Planning Commission Report

Meeting Date: September 26, 2011

Subject: **9230 Wilshire Boulevard
Jim Falk Lexus**

Request for a Zone Text Amendment, Conditional Use Permit, Encroachment Permit and Alley Vacation to allow the demolition of the existing Jim Falk Lexus Dealership and construction of a new 45-foot tall (48-feet 6-inches to top of parapet and 59-feet to top of stair tower), dealership containing 352 vehicle parking and storage spaces within a four-level building with two levels of subterranean service bays.

ATTACHMENT C
PROPOSED TURN RESTRICTION BARRIER
(SOUTH MAPLE DRIVE)

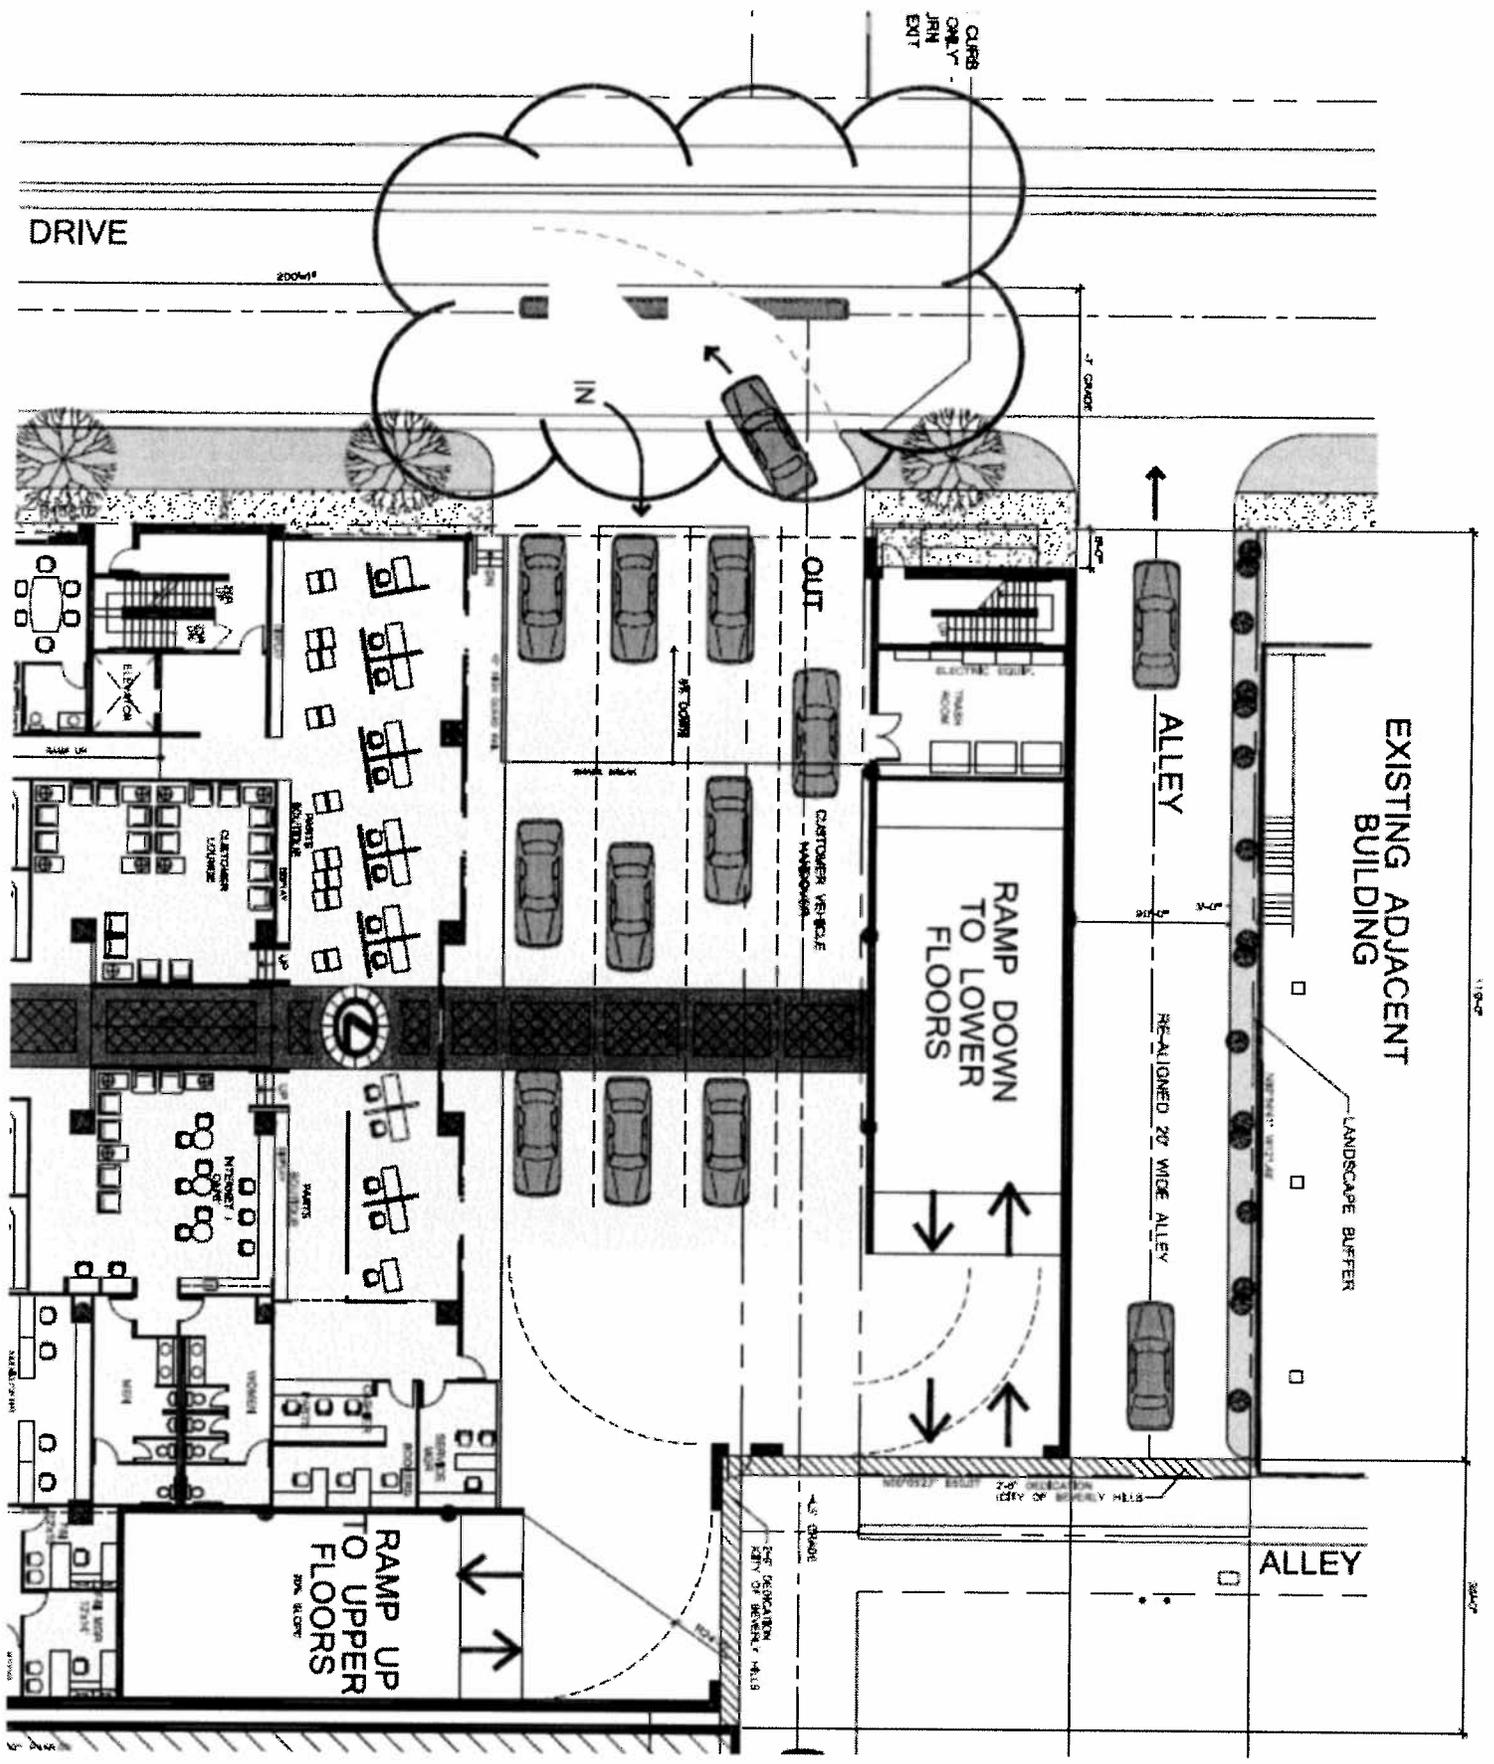
The most recently proposed project did not include a physical barrier on South Maple Drive to prevent vehicles traveling northbound on South Maple Drive from making a left turn into the dealership. Based on direction from the Planning Commission subcommittee the applicant is proposing a physical barrier on South Maple Drive to prevent northbound traffic from making left turns into the dealership. The goal of the barrier is to prevent dealership patrons from utilizing the surrounding residential streets for the purpose of accessing the dealership, and to instead direct traffic to Wilshire Boulevard. Attachment C provides preliminary details of the proposed barrier's configuration; however, any approval of such a barrier by the Commission would be conditioned to require final design approval by the Director of Public Works to ensure a safe, effective configuration.
